**Re: Waste Licence Application W0231-01 Fingal Landfill –
Submission on Behalf of the Nevitt Lusk Action Group**

Following the recent Oral Hearing on the proposed Fingal Landfill, the following submission is being made on behalf of the Nevitt Lusk Action Group (NLAG). This submission has been compiled on the basis of data presented to An Bord Pleanala during the Oral Hearing by Fingal County Council and their team of consultants. The NLAG did not have an opportunity to review this data as part of their previous submission as it was not included in the EIS.

GEOLOGICAL CROSS SECTION A-A'

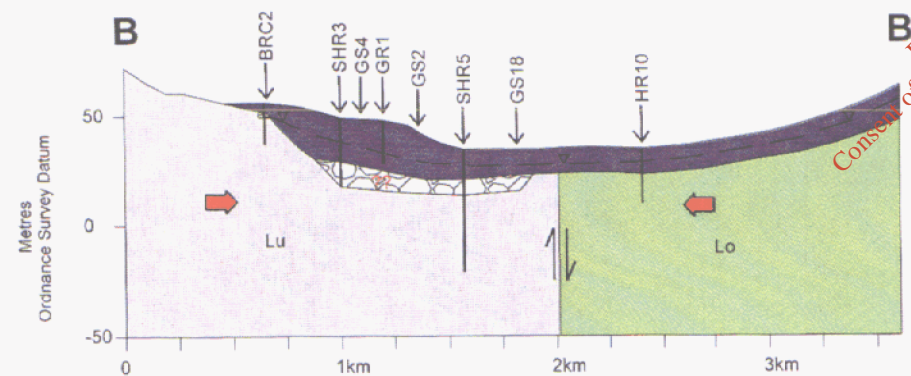
Appendix A1.1 (of Technical Appendix H & I) of the EIS presented two geological cross sections of the site displayed on an A4 page. There are a number of issues with these cross sections which render them inadequate for assessing the suitability of the site for a landfill:

- The horizontal scale of 1:25,000 means that 1km on the ground is represented on the page by just 0.04m. Such a scale is considered inadequate for representing the complex geological and hydrogeological conditions underlying the site. A horizontal scale of 1:5,000 or 1:10,000 would be more suitable.

- A total of two cross sections representing the subsurface at a 200 hectare site is completely insufficient. Given the complexity of the subsurface a minimum of six cross sections should have been presented.

- The lines of section across the site selected for inclusion in the EIS have been poorly selected. The north-south trending Section A-A' represents the western extent of the landfill footprint. In order to have a representative north south orientated picture of the subsurface underlying the landfill footprint, a line of section should have been along the western extent, through the centre and along the eastern extent of the footprint. Similarly, the west-east trending Section B'-B' only represents the southern portion of the landfill footprint. Several lines of section should have been produced representing the northern, central and southern portions of the site in an west-east orientation.

- Therefore, WYG suggest that the cross section data presented in the original EIS is not sufficient to make an informed decision on the suitability of this site for a landfill.

On Day 5 of the Oral Hearing (Friday 20th October) hydrogeological consultant for Fingal County Council, RPS Consulting Engineers, introduced a revised cross section displayed on an A3 page. The revised version of the cross section varies significantly from the original submitted in the EIS. The revised cross section clearly shows the landfill footprint overlying gravel. This directly contradicts the assertion in the EIS (Volume 5 Technical Appendices H & I Page 15) which states;

The cross sections submitted by Fingal County Council themselves renders this statement from the EIS false and incorrect. Furthermore, the inconsistencies between the cross sections highlights the inaccuracies in the assessment carried out by Fingal County Councils consultants.

Extent of Gravel Deposits underlying low-permeability Superficial Deposits (overlying rockhead)

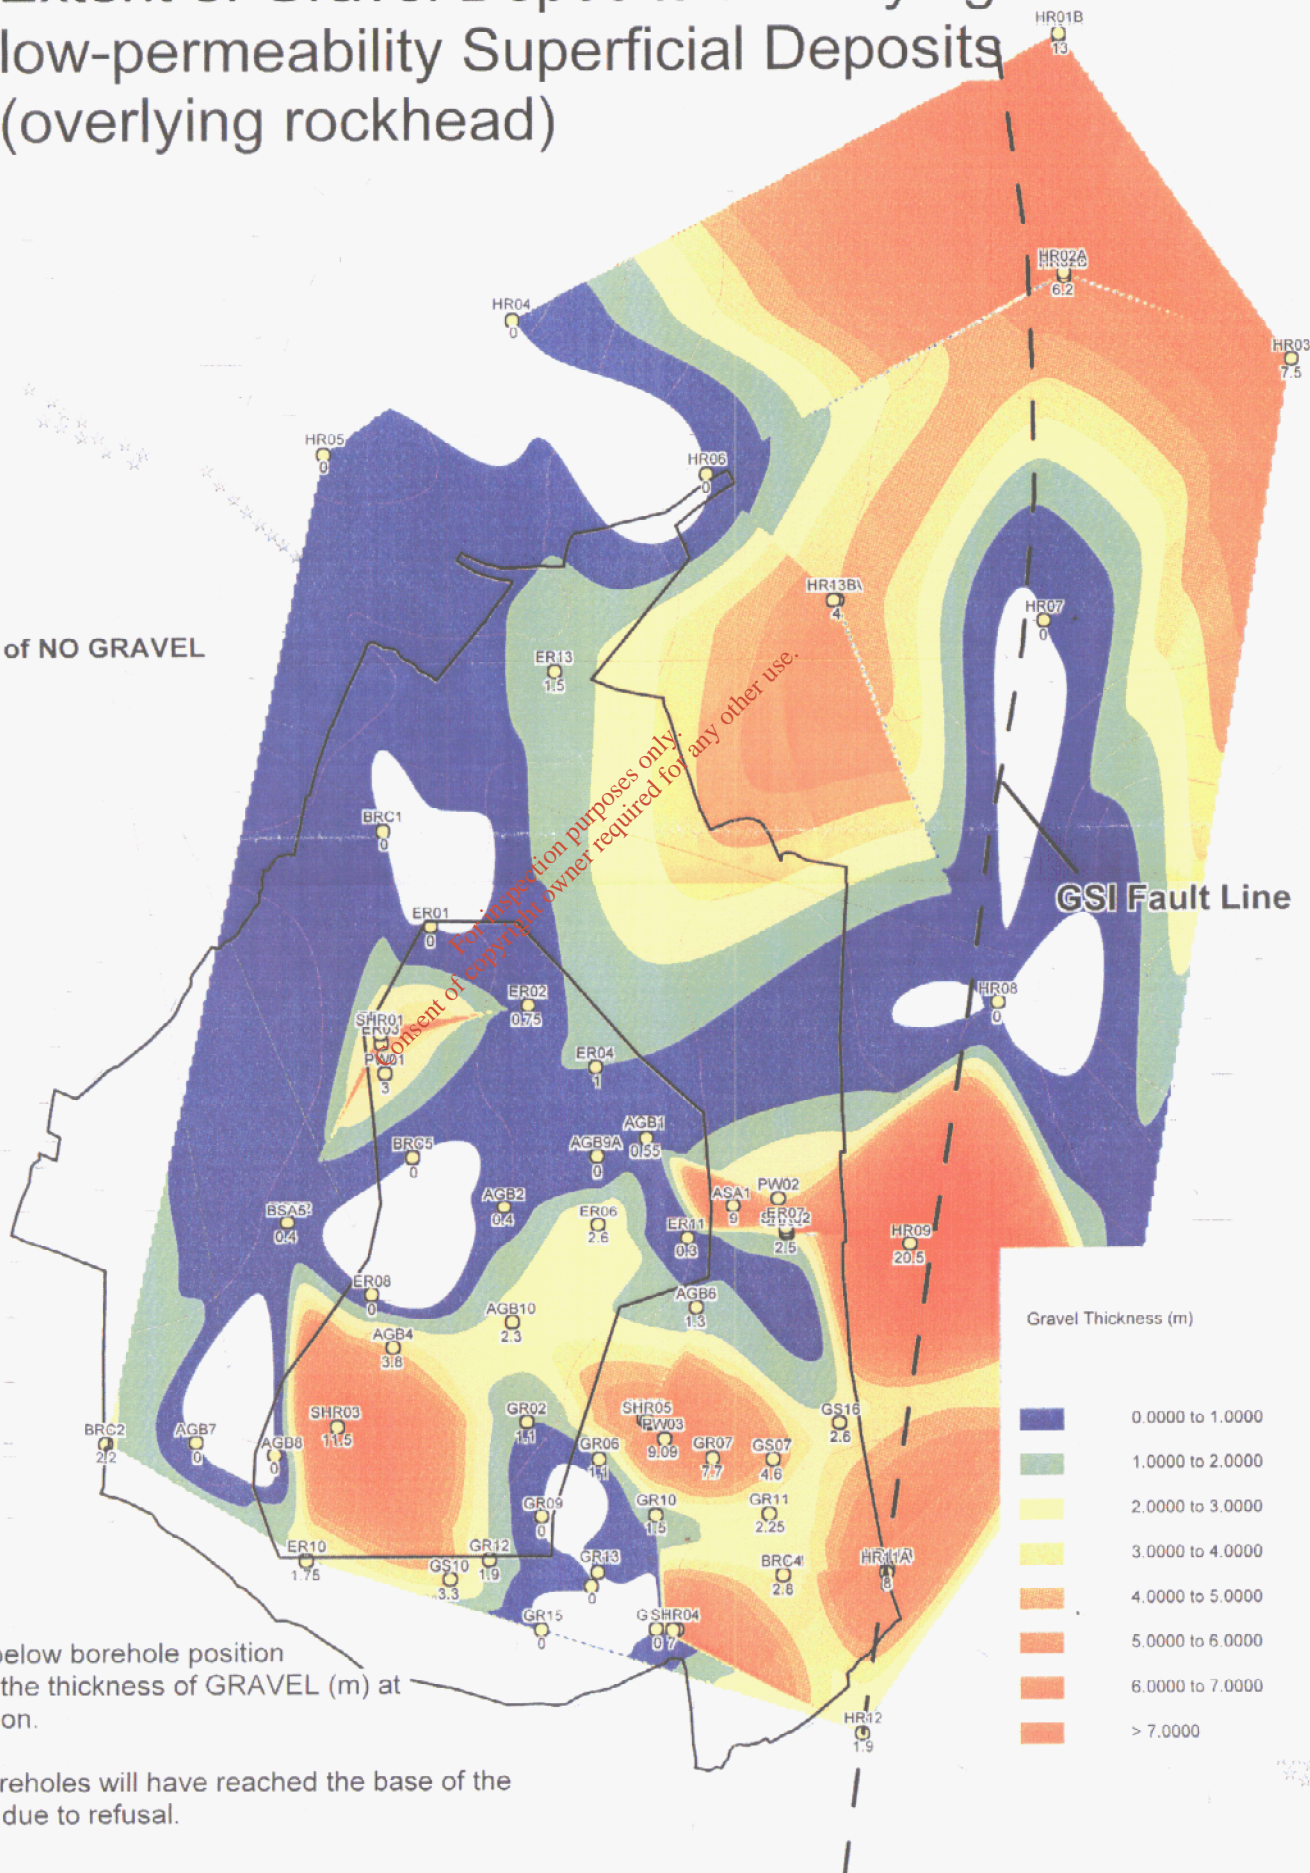
This figure clearly demonstrates that almost the full extent of the landfill footprint is underlain by gravel. Again, this directly contradicts the statement in the EIS that gravel areas “lie outside the landfill footprint”.

This figure is considered to be of limited use as it displays the thickness of the gravel layer underlying the landfill footprint rather than the depth below the surface that this gravel layer occurs. A figure showing the depth below the surface to gravel would clearly show that at the location of Borehole AGB4, in the mid-west section of the footprint, gravel is recorded at just 0.7m depth below the surface. The gravel at this location is greater than 3.8m thick. The exact thickness of gravel is unknown as the borehole was finished at 4.5m below ground level (bGL) before it emerged from the gravel into clay or bedrock. Borehole ASA3, within the landfill footprint, recorded sand at 4.1m bGL while GS10, on the southern boundary of the footprint, recorded gravel at just 4.5m depth.

Proposed Fingal Landfill Bedrock Geology and Rock Level (mod) Profile

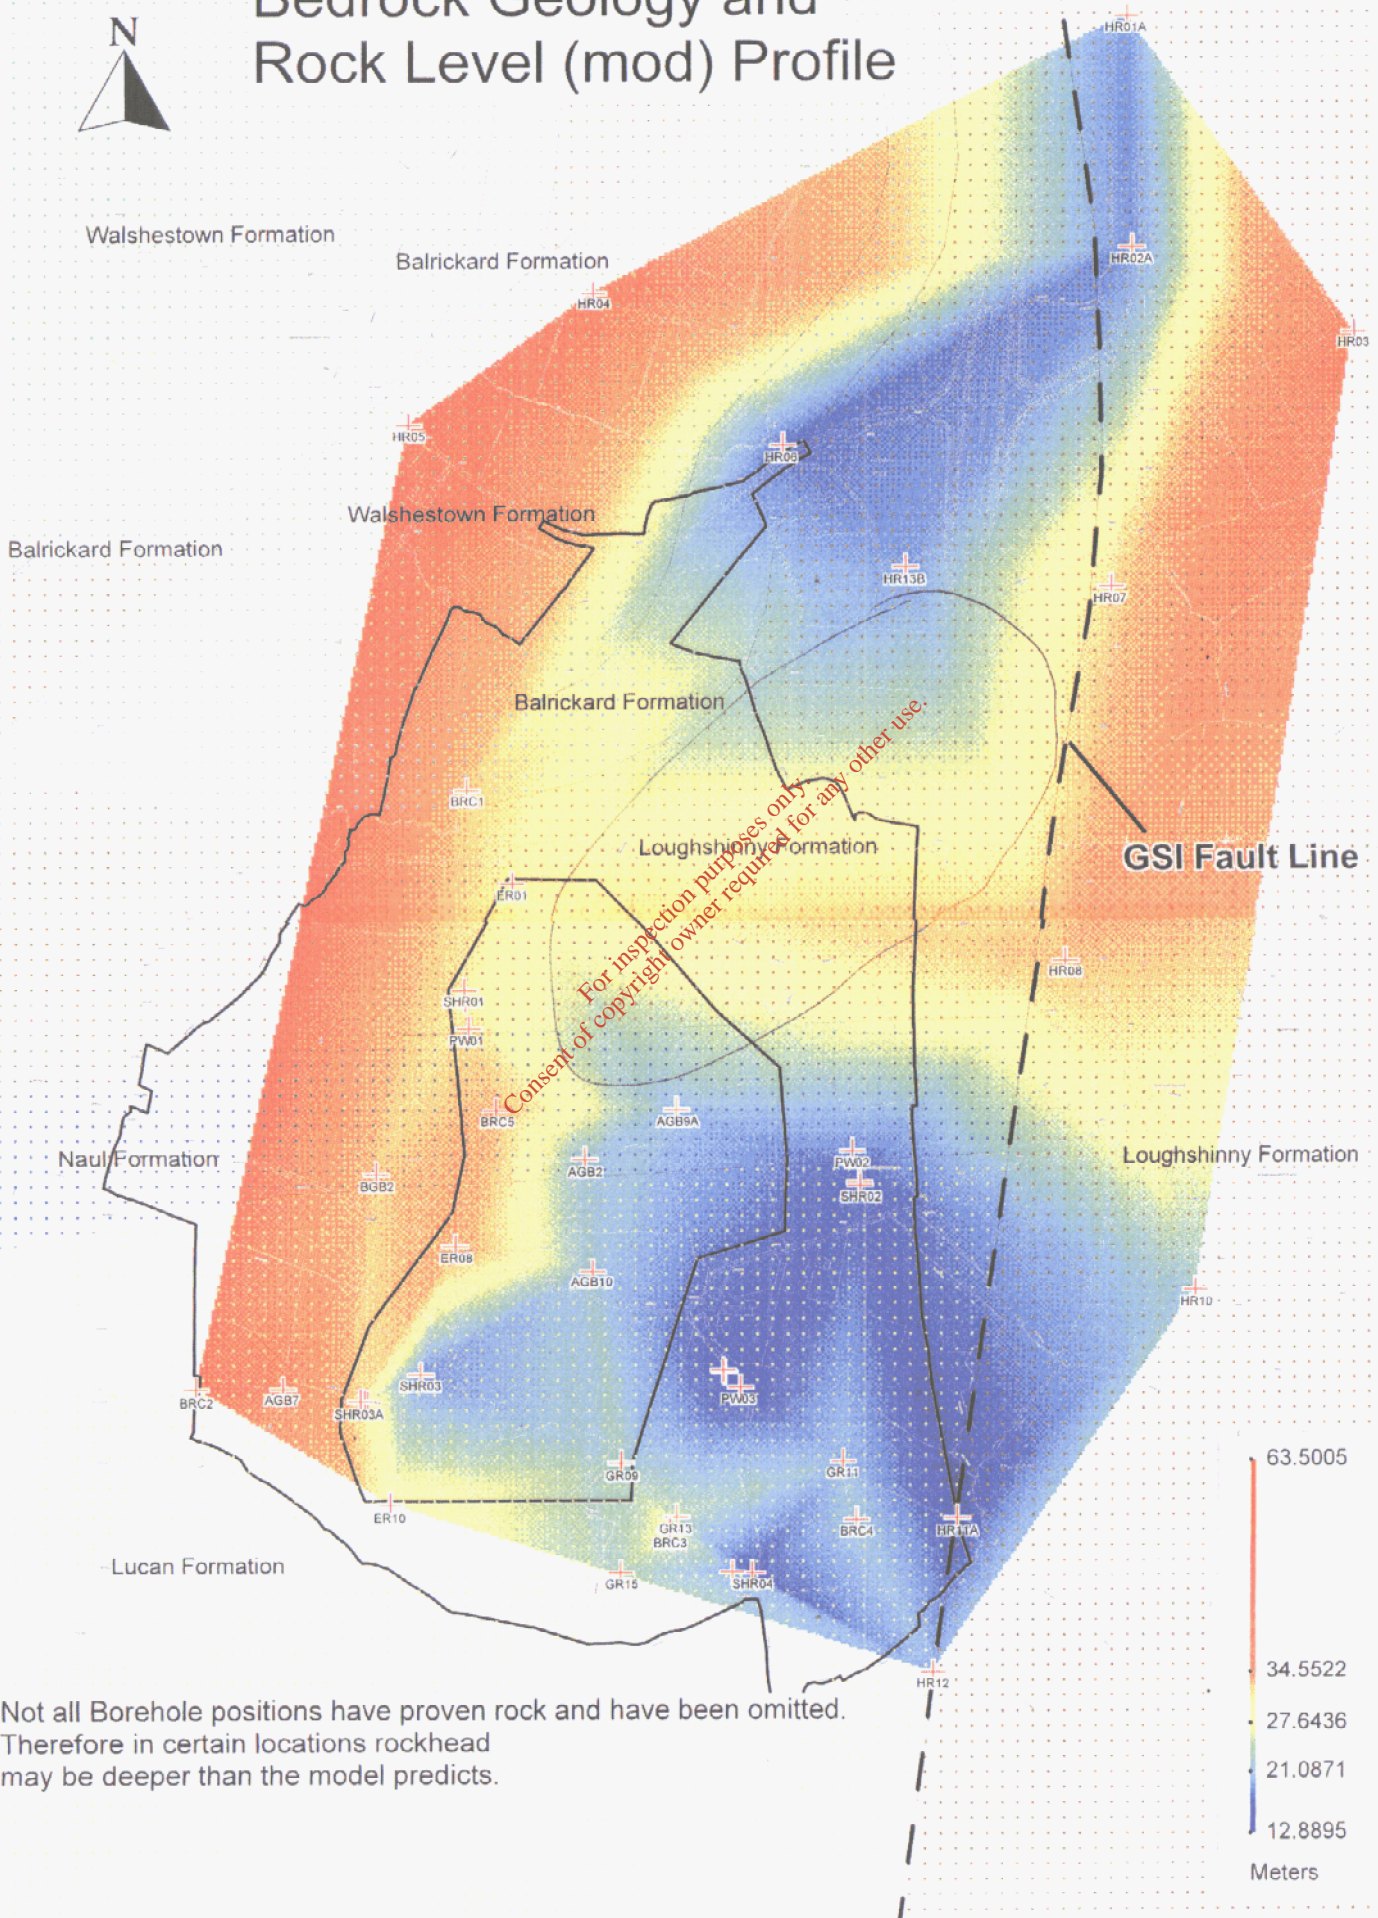
This figure highlights the lack of site specific data that contributed to the conceptual model of the geology presented in the EIS. The lithology distribution and the position of the north-south trending fault are based on information published by the Geological Survey of Ireland. The boreholes drilled on site have not been used to confirm the positions of the boundaries between the three limestone formations that the GSI indicates underlie the footprint. In addition, the drilling information and the geophysical surveys were not used to refine the position of the north south trending fault. Several ‘possible faults’ identified by the geophysical investigation were not considered in the EIS and no investigations appear to have been undertaken to confirm their presence or to establish their extent or significance.

This figure indicates that the top of the bedrock is closest to the surface in the west of the landfill footprint and again just to the north of the footprint. It is unclear whether or not this subsurface topography influences the groundwater flow pattern within the area. For example, it is unclear from the EIS if this topographic high within the bedrock acts as a groundwater divide with groundwater moving southeast on the southern side of the bedrock feature and moving northeast to the north of the bedrock feature. It is unfortunate that this information was not included in the EIS and that it was not considered in producing the groundwater contour maps.

**Preliminary Source Protection Zones for Kerrigans and
Moore's Well**

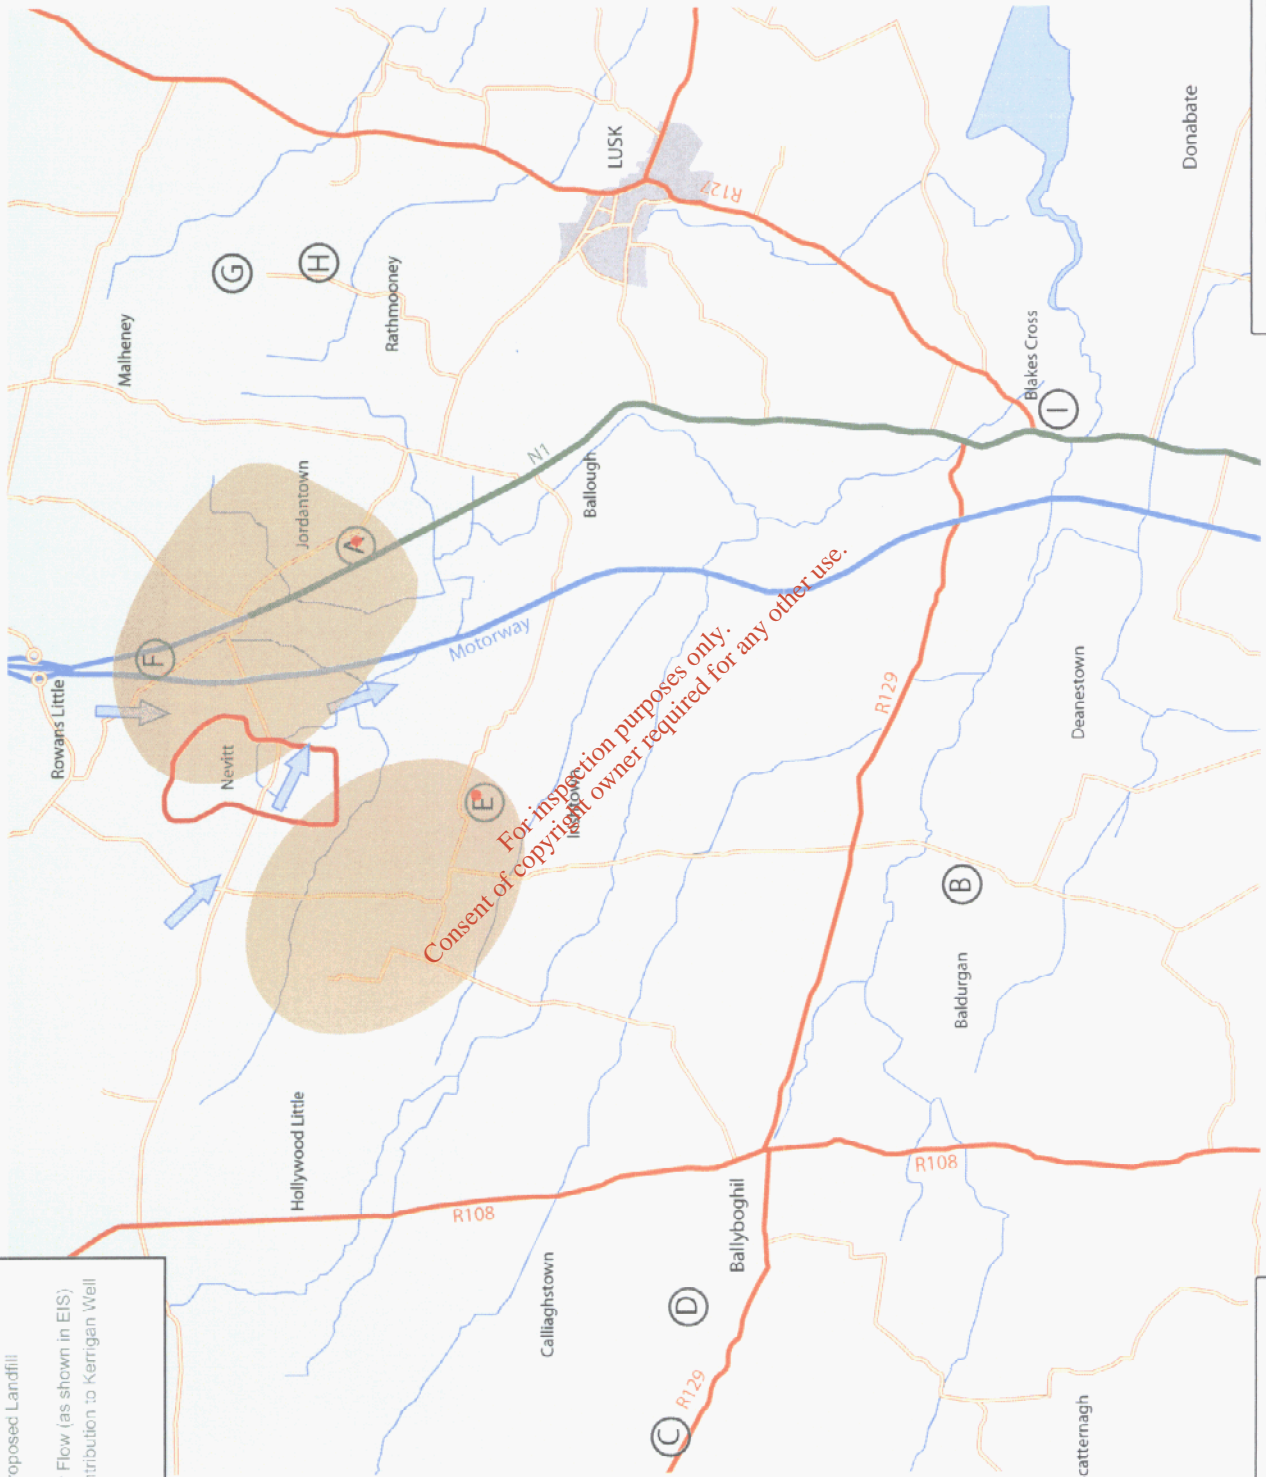
The EIS did not take account of the zones of contribution to these wells. In order to demonstrate the likely extent of the zone of contribution to these wells, the source protection areas were delineated provisionally using the data available in the EIS. Although these ZOC's are not definitive and have been determined using a limited data set, they are a good representation of the area that will be contributing groundwater to these sources. They have been delineated using a recharge rate of 57mm/yr (as per EIS) and using the abstraction rates as indicated by the well owners. Kerrigans Well is reported to have an available yield of 1962m³/d and Moores Well 654m³/d. Using the recharge equation, the geographical areas required to maintain these abstractions based on 57mm/yr recharge are displayed on Figure 1 attached. The area for Kerrigans Well is some 3925351m² and some 4187894m² for Moores Well.

A zone of contribution to a source will naturally extend in an upgradient direction away from that source. Therefore, the ZOC's to both wells extend upgradient and towards the location of the proposed landfill and as such the ZOC's intersect the landfill footprint area. This is significant in that the groundwater protection responses for landfills within a source protection area are completely different to the response outside a ZOC.

It is therefore recommended that the EIS delineate the source protection areas for the wells considered to be at risk of becoming contaminated from the proposed landfill. The EIS should then be revised based on the DoELG/EPA GSI (1999) Groundwater Protection Response Matrix for Landfills to establish the suitability of the site for a landfill. This matrix is attached at the end of this submission for ease of reference. Should the response category change to either R3¹ or R4 then the suitability of the site for a landfill must be reconsidered.
